From: Rael, Rudy E.
Sent: Thursday, September 08, 2016 2:55 PM
To: 'David Soule (david@riograndeengineering.com)'
Subject: 8009 Camino Alto NW

Based upon the information provided in your submittal received 8/26/16, the above referenced Grading and Drainage Report and plan cannot be approved for Grading Permit or Building Permit until the following comments are addressed:

LOT 22 BLOCK 6 UNIT 22 VOLCANO CLIFFS SUBDIVISION	DRAWN BY JDG
	GRADING AND DRAINAGE PLAN	DATE 08-25-2016
8/25/16		SHEET # 1 OF 1
DAVID SOULE P.E. #14522	1606 CENTRAL AVENUE SE SUITE 201 ALBUQUERQUE, NM 87106 (505) 872-0999	JOB #

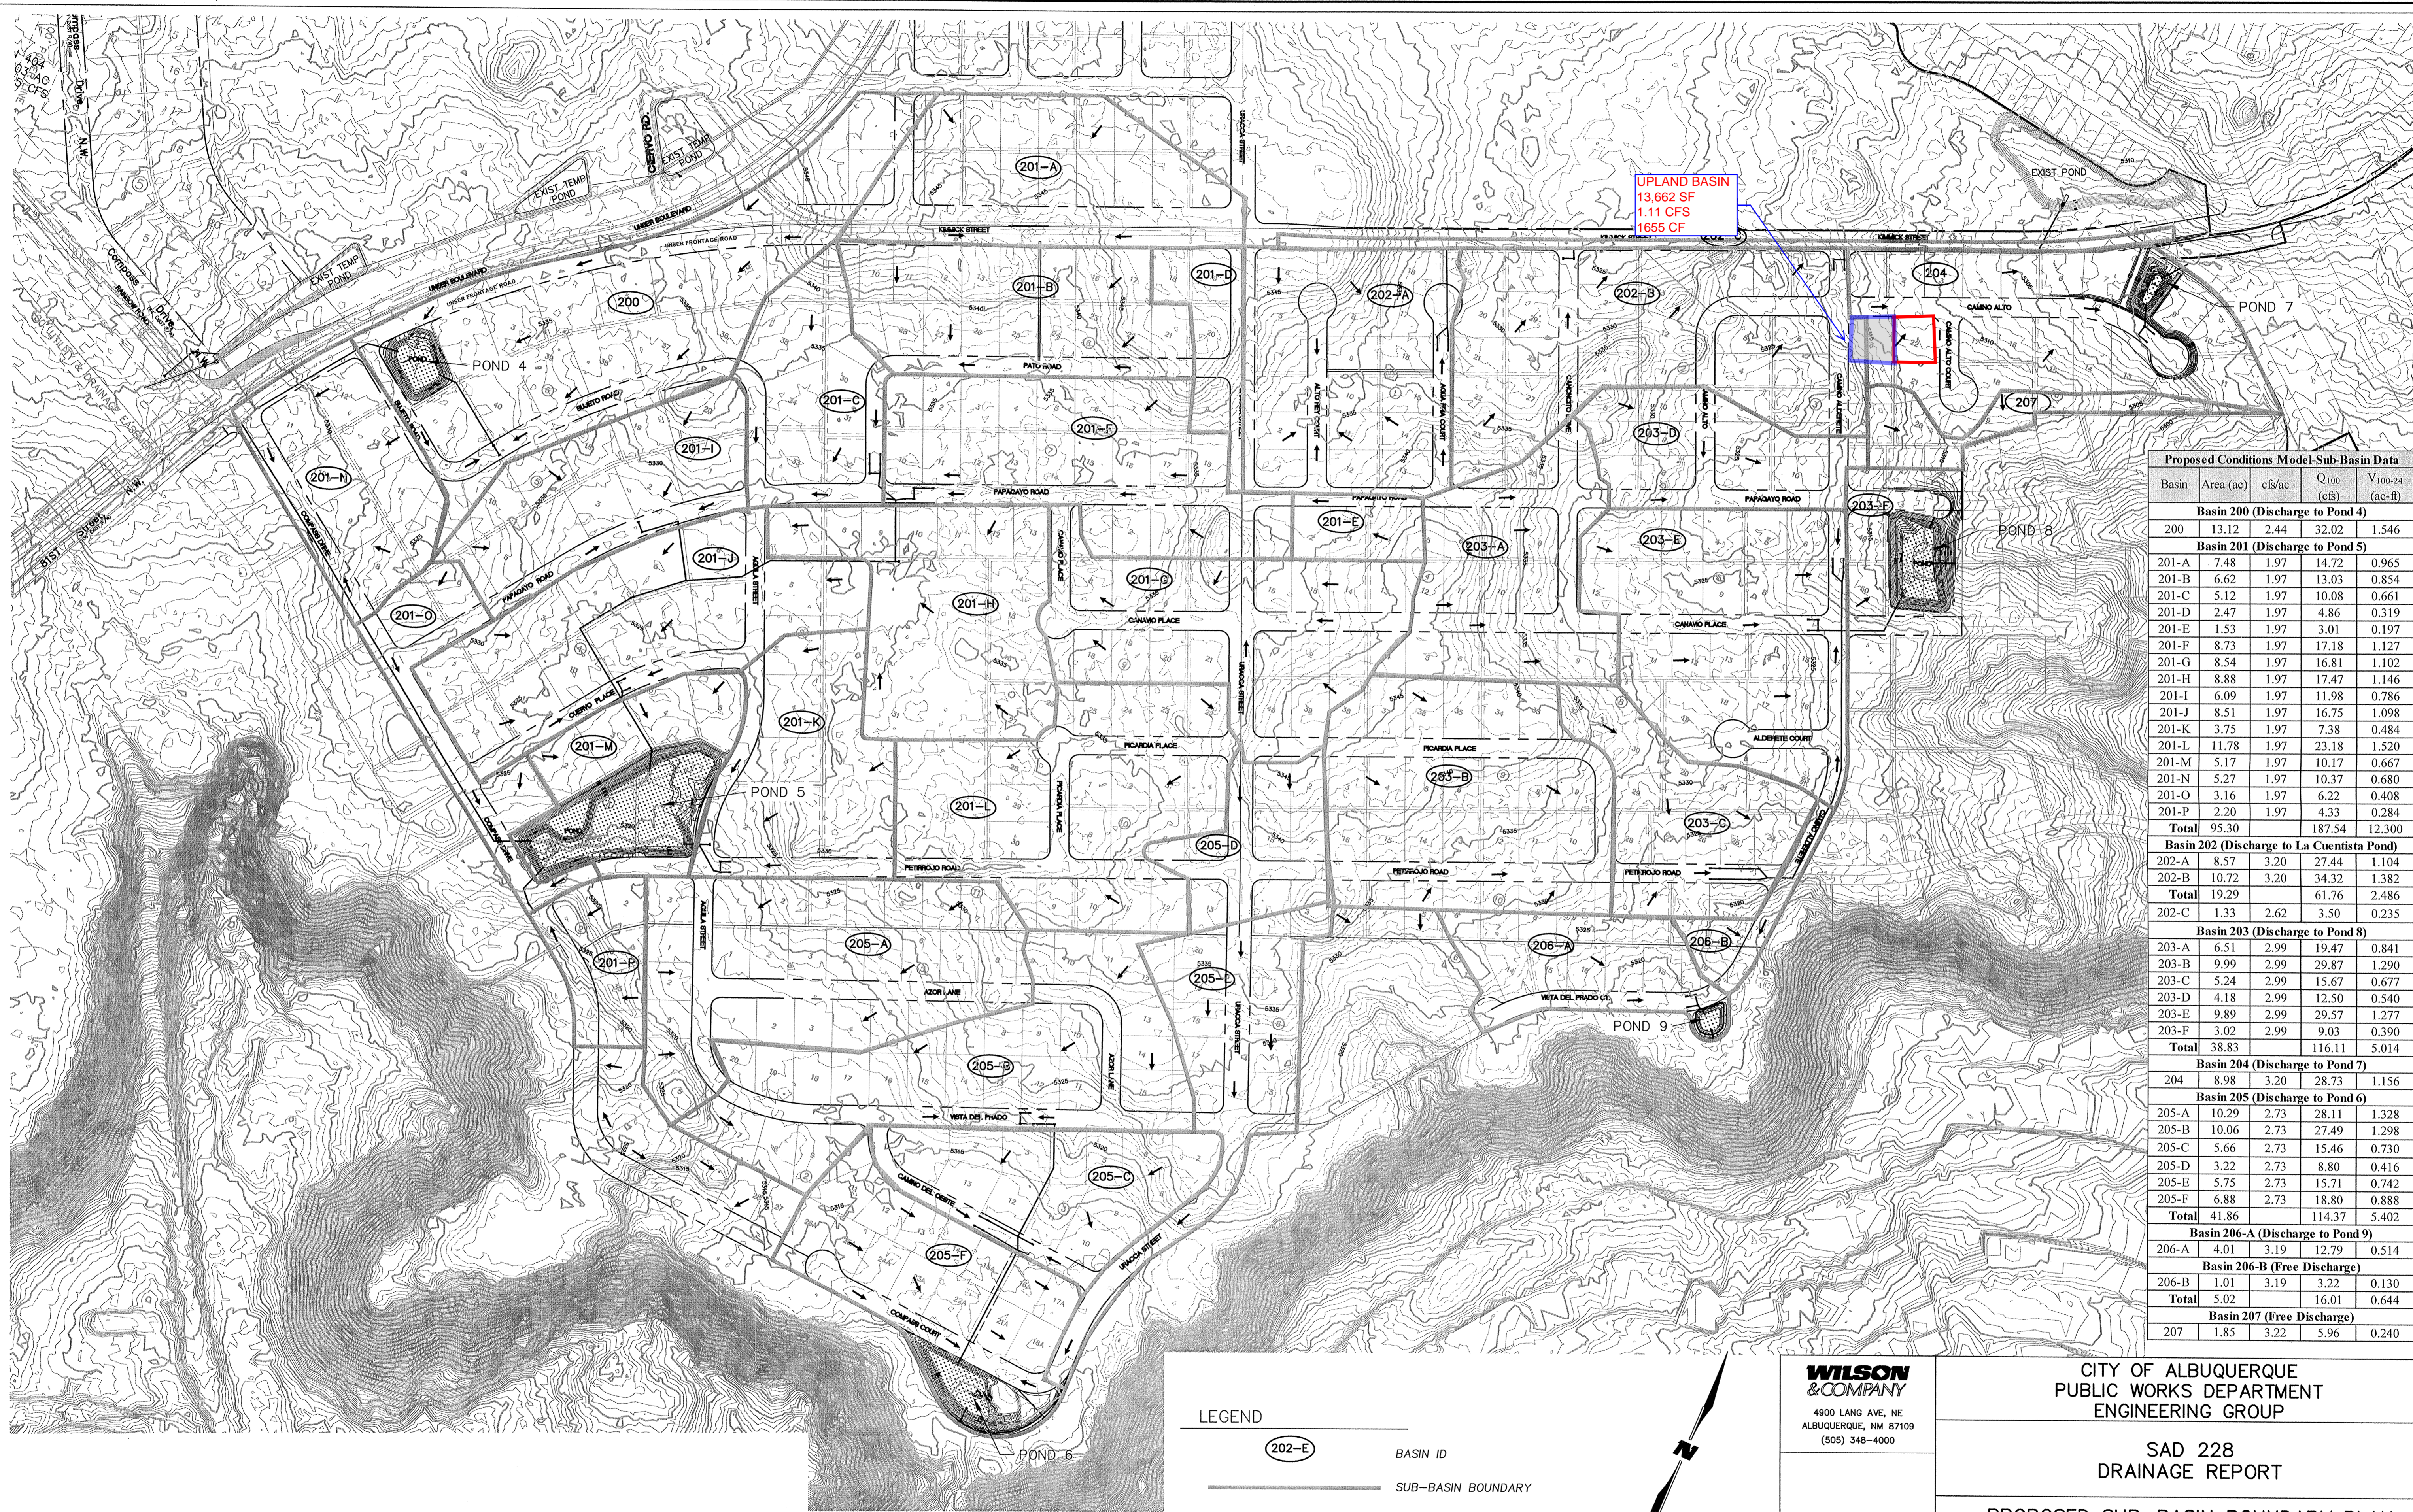
1. Provide a statement in the SW corner of the plan about an opening in a wall which is required for flows to enter from the south property.
2. Correct the city address on the DTIS, it shows 6308 Papagayo NW.
